MODIFICATION REQUEST: Sydney Adventist Hospital Alterations and Additions 185 Fox Valley Road, Wahroonga (MP10_0070 MOD 3)

- modification to the built form of the Education Centre, including a height reduction from three to two storeys and larger building footprint.
- construction and provision of an additional 34 car spaces.

Director-General's
Environmental Assessment Report
Section 75W of the
Environmental Planning and Assessment Act
1979

June 2012

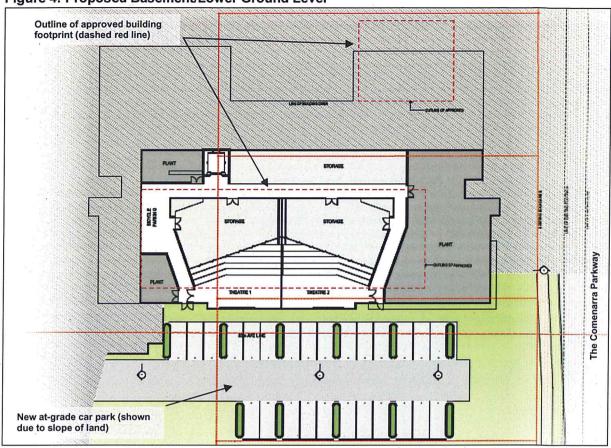
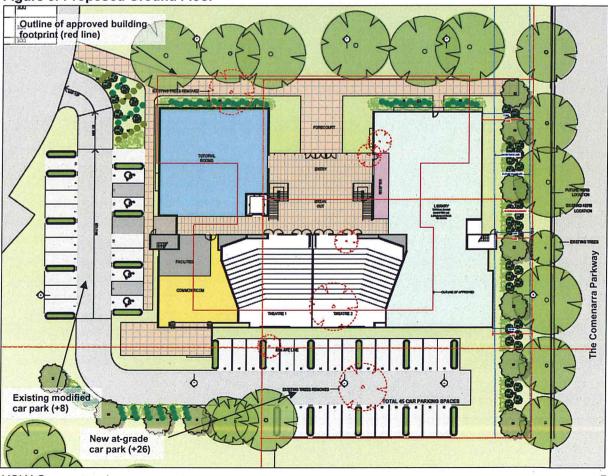
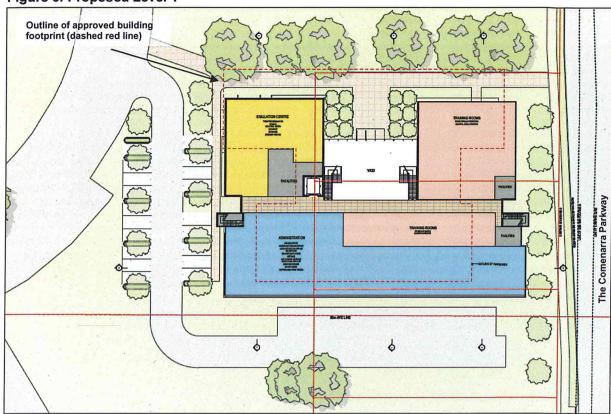
- decrease in building height by approximately 4.1m, from three storeys to two storeys
- increase in building footprint due to redistribution of GFA over two levels
- amended façade design to reflect the amended two storey design
- amendment to the existing education centre car park and construction of new at-grade car park to provide an additional 34 spaces.

- The size and location of the car park has been significantly altered. Council requests that the split car parks be combined into one area located close to the hospital's existing internal ring road and remove the proposed car park adjacent to The Comenarra Parkway.

The modification request seeks approval to amend the existing education centre car park and for the construction of a new car park on the western side of the education centre, to make provision for an additional 34 car parking spaces. Access to the car park would be provided via the approved 9 space car park.

The Department considers the additional parking spaces appropriate for the education centre. The additional parking spaces will not detrimentally impact on the surrounding road network, to which future road upgrades will satisfactorily cater for the hospital redevelopment, including the envisaged student and staff population. The proposed location, while taking up additional soft landscaping space, will be suitably screened and will not detrimentally impact on the existing setting.

Figure 8: Proposed North Elevation

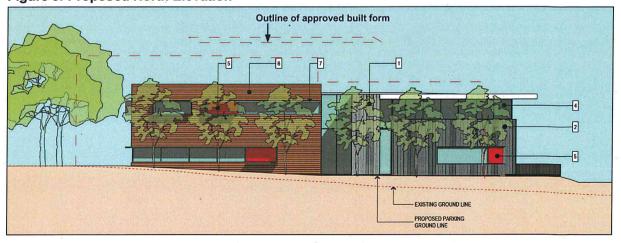
- Height reduction seen as a positive step towards acknowledging the single and double storey homes that form The Comenarra Parkway streetscape.
- Requested that the drawings be corrected to detail the true height and setback of residential development fronting the southern side of The Comenarra Parkway.

The maximum height of the building has been reduced from 14.9m to 10.8m. Importantly, the height of the building's frontage to The Comenarra Parkway has been reduced from approximately 12.6m to 9.5m, creating a more sympathetic built form in response to the existing 1 to 2 storey residential buildings fronting the southern side of The Comenarra Parkway.

Figure 11: Ground Floor Plan Extract - Future Building Setbacks

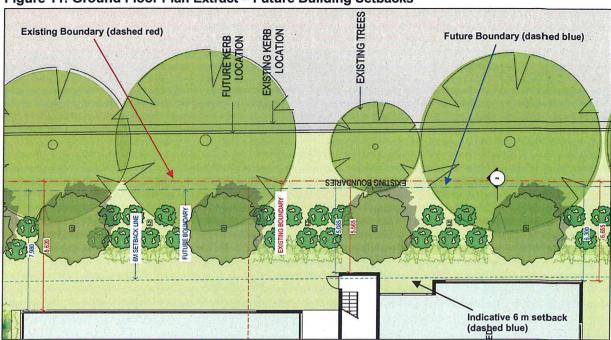
- The drawings do not accurately show the 6m building setback to the property boundary affected by scheduled road widening works on The Comenarra Parkway. Council requests that the new actual property boundary line and setback, post road-widening, be clearly indicated on the drawings.

- The modification proposes a substantially reduced building setback to The Comenarra Parkway and will reduce the available landscape area for planting. Council requests that the education centre building have a minimum 12m setback to the new property boundary line on The Comenarra Parkway.

The proposed removal of the third level from the education centre results in a slightly larger building footprint to accommodate the approved 3,500sqm of floor space. Consequently, the amended design proposes a reduced setback to The Comenarra Parkway, proposing a setback between 6.3m — 7.98m, subject to a minor encroachment of the stairwell that is proposed to be setback 5.08m.

Council has raised concerns regarding the reduced setback from that previously approved (varying between approximately 10m – 16m), noting that the proposed scale of the education centre is consistent with a 3 storey residential flat building (RFB), which Council requires to be setback a minimum 10m to a maximum 15m. In addition they advised that existing residential dwellings fronting The Comenarra Parkway provide setbacks of between 9m and 12m.

The Department is of the opinion that the proposed amended 9.5m – 10.8m scale of the education centre is not considered to be consistent with a 3 storey RFB. Furthermore, the approved Wahroonga Estate Concept Plan (MP07_0166) identifies a minimum 6m setback requirement to a 2m verge on the northern side of The Comenarra Parkway. In this regard, the proposal is generally consistent with the concept plan, subject to the minor encroachment of the stairwell, while the existing verge to The Comenarra Parkway would be maintained at approximately 3m in width.

The Department acknowledges that the future road widening works to The Comenarra Parkway may impact on the existing property boundary alignments and accompanying building setbacks. However, the proponent has provided information detailing the design of the proposed upgrades and future property boundary, that satisfactorily details the proposed amended education centre will achieve a 6m setback, subject to a minor encroachment of the stairwell (see Figure 11).

The Department considers that the amended building design and footprint are satisfactory and will provide an improved built form response to the existing streetscape character of The Comenarra Parkway. Further, the setbacks proposed maintain consistency with the approved Wahroonga Estate Concept Plan and will ensure that existing landscaping is maintained and that the potential for future landscaping exists.

Figure 12: Recommended Landscaping

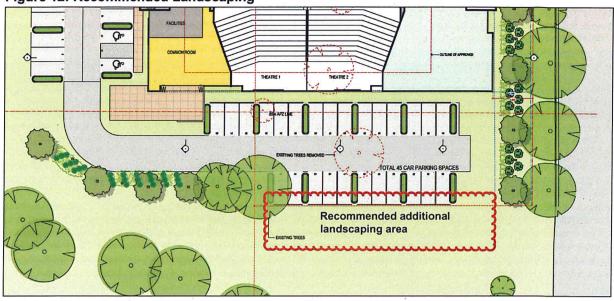
Concerns were raised in relation to the lack of available landscape area for the establishment of screen planting for both the proposed amended built form and proposed new car park extension. A number of mature street trees exist along the northern side of The Comenarra Parkway and are identified as being required for retention. Details provided by the proponent in relation to the future road widening works confirm that these existing trees are capable of being maintained. Further, additional screen planting is proposed along the northern façade of the building that will provide suitable screening of the proposed built form.

The Department considers it appropriate that additional screen planting be provided to the proposed new 34 space car park. Accordingly, a new condition is recommended to ensure that the length of the western edge of the new 34 space car park extension is suitably screened with vegetation (area outlined in red in Figure 12). The establishment of such vegetation within this location will ensure that the character of the existing streetscape is appropriately maintained.
